Project: IEEE P802.15 Working Group for Wireless Personal Area Networks (WPANs)

Submission Title: [Consideration of MR-FSK Channelization and Clock Frequency Tolerance Using Filtered FSK]

Abstract: [Evaluation of the MR-FSK channelization scheme and the effect of clock frequency tolerance with filtered FSK as modulation format.]

- This contribution is submitted as a follow-up to the discussion of the DCN834rev1 at the November meeting in Dallas.
- Comments addressed: CID #186 and #687
- Since the 802.15.4g MR-FSK PHY specifies the use of *filtered* frequency shift keying for good co-existence practice, the most realistically way to evaluate the channelization scheme and the effect of clock frequency tolerance is by using a filtered FSK signal.
- GFSK with $BT=0.5$ will be used as the filtered FSK modulation format in this evaluation.

Filtered FSK Signals at 915 MHz, ± 30 ppm (1)

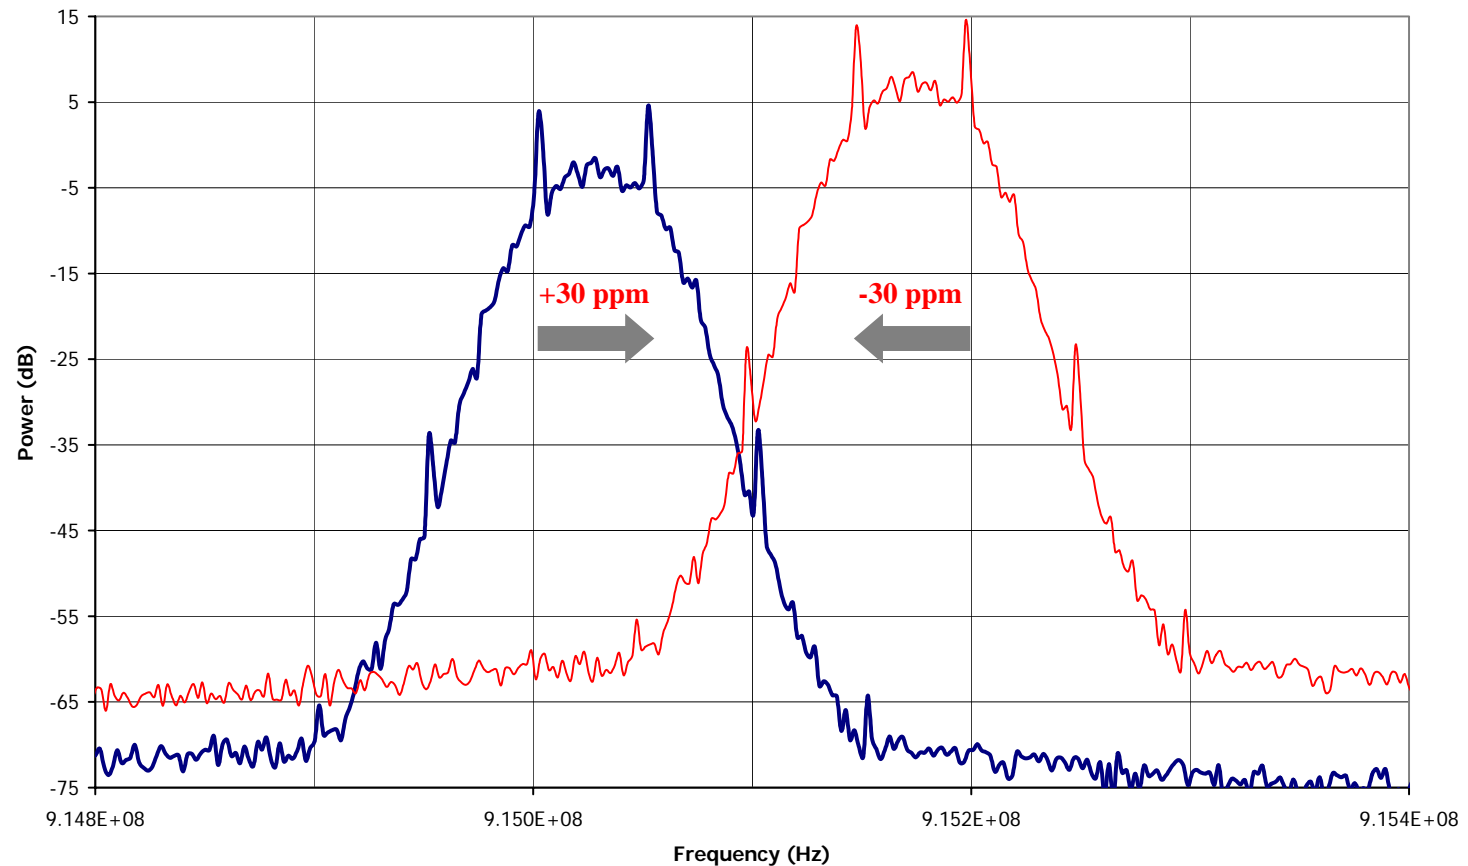
- Negligible interfering power leakage from adjacent channel at max frequency tolerance and worst case offset.

Filtered FSK Signals at 915 MHz, ± 30 ppm (2)

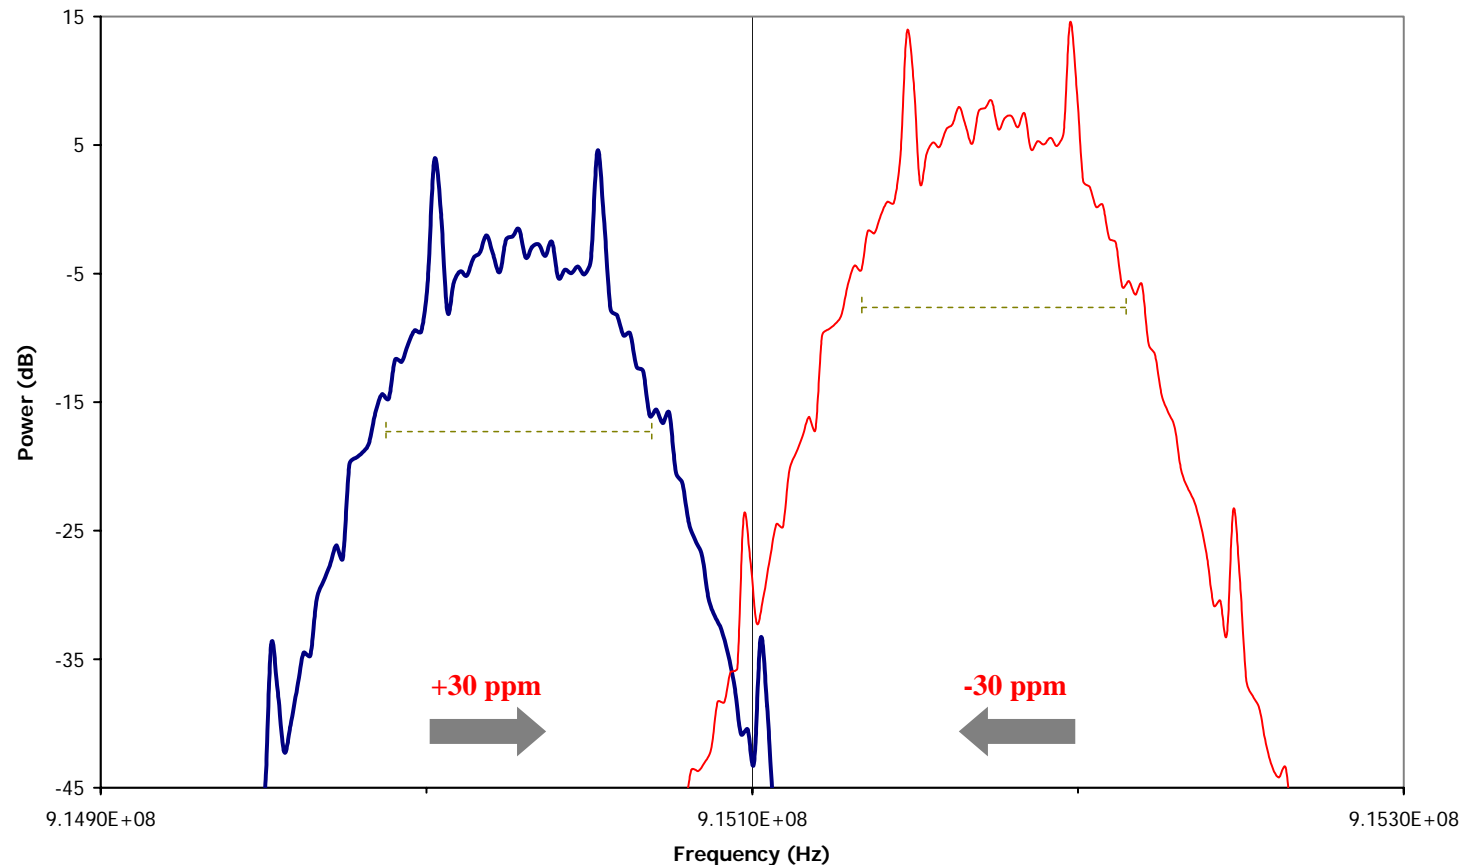
- Excellent conditions for signal demodulation at max frequency tolerance and worst case offset.

Filtered FSK Signals at 2450 MHz, ± 15 ppm (1)

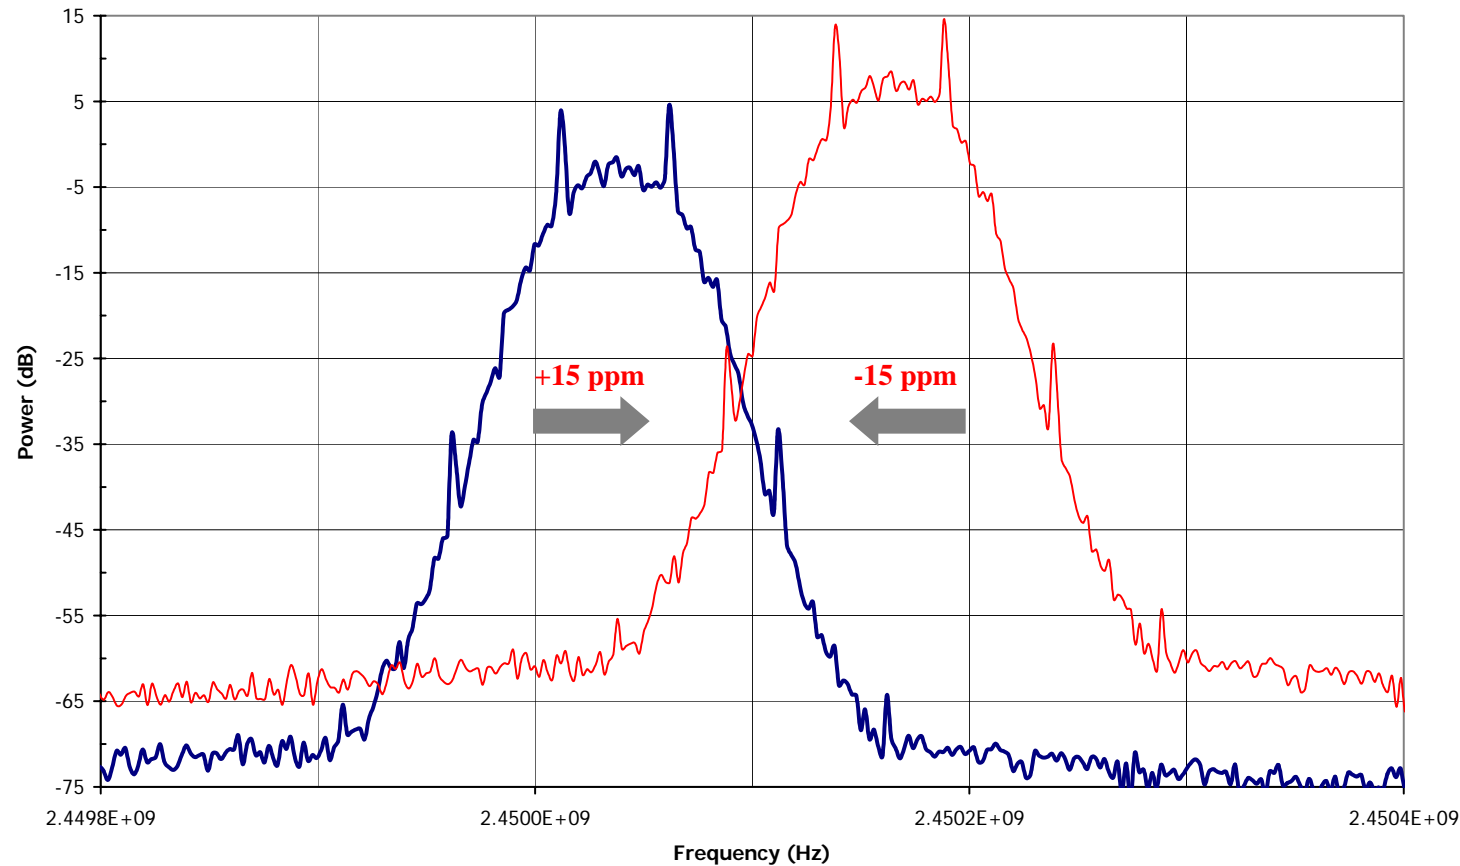
- Negligible interfering power leakage from adjacent channel at max frequency tolerance and worst case offset.

Filtered FSK Signals at 2450 MHz, ± 15 ppm (2)

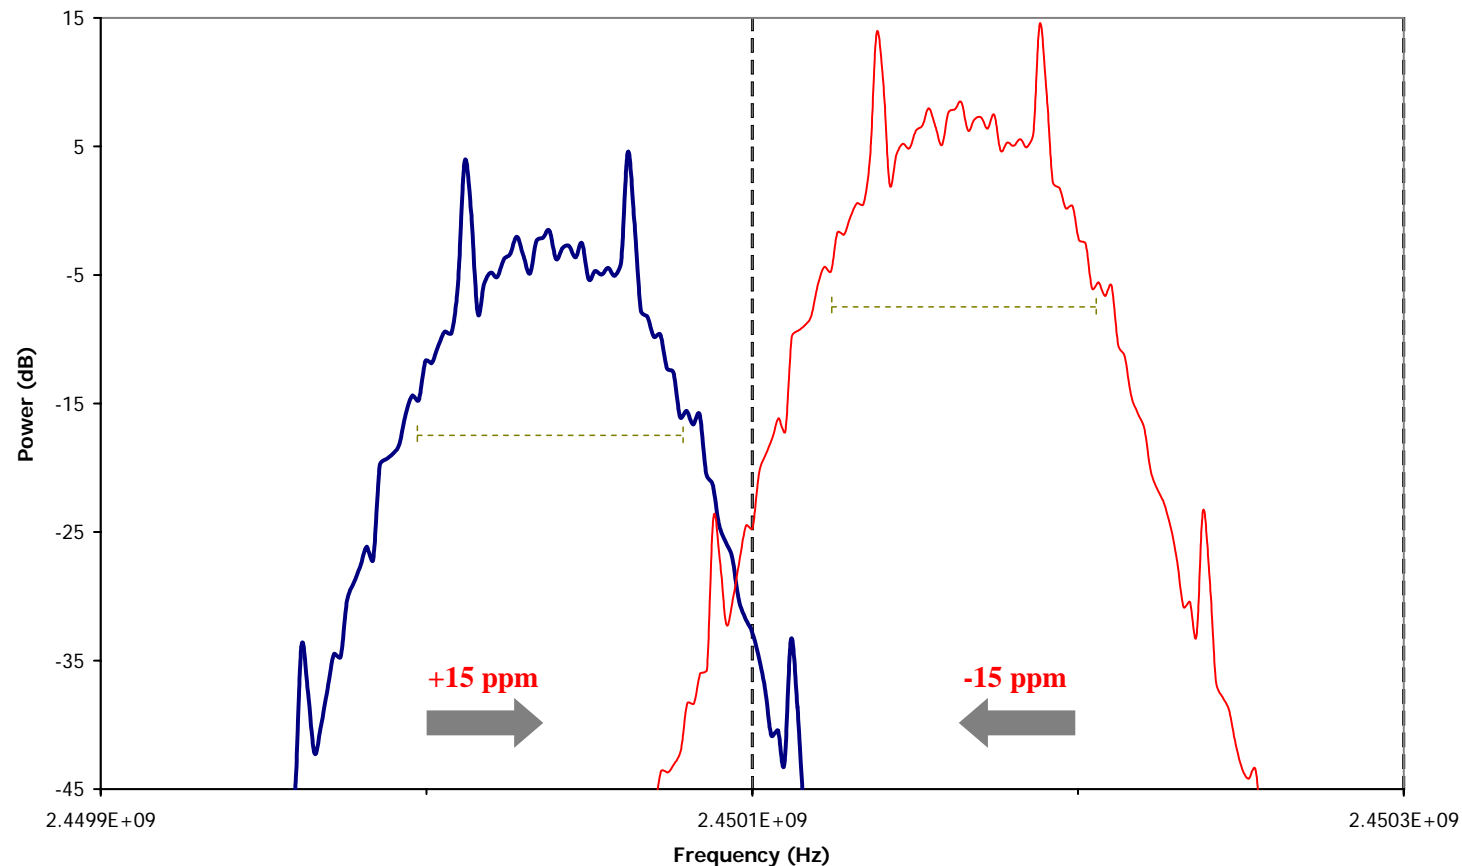
- ± 15 ppm (max frequency tolerance)
- Worst case frequency offset
- All signal power contained within the channel
- Good conditions for signal demodulation

Filtered FSK Signals at 2450 MHz, ± 20 ppm

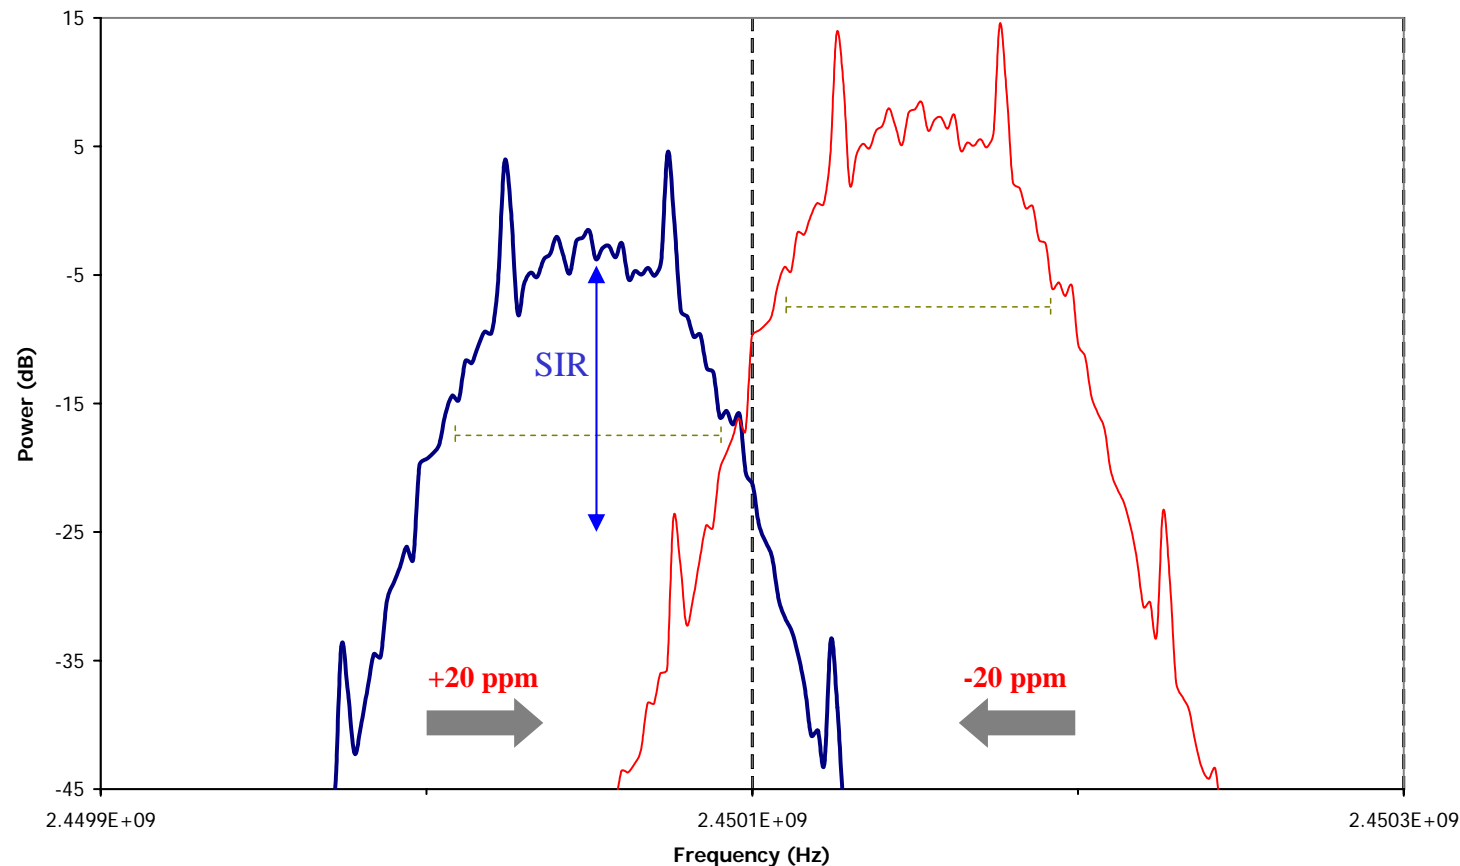
- ± 20 ppm (33% higher than currently specified)
- Worst case frequency offset
- Most of signal power (>99%) still contained within the channel
- Adequate conditions for signal demodulation
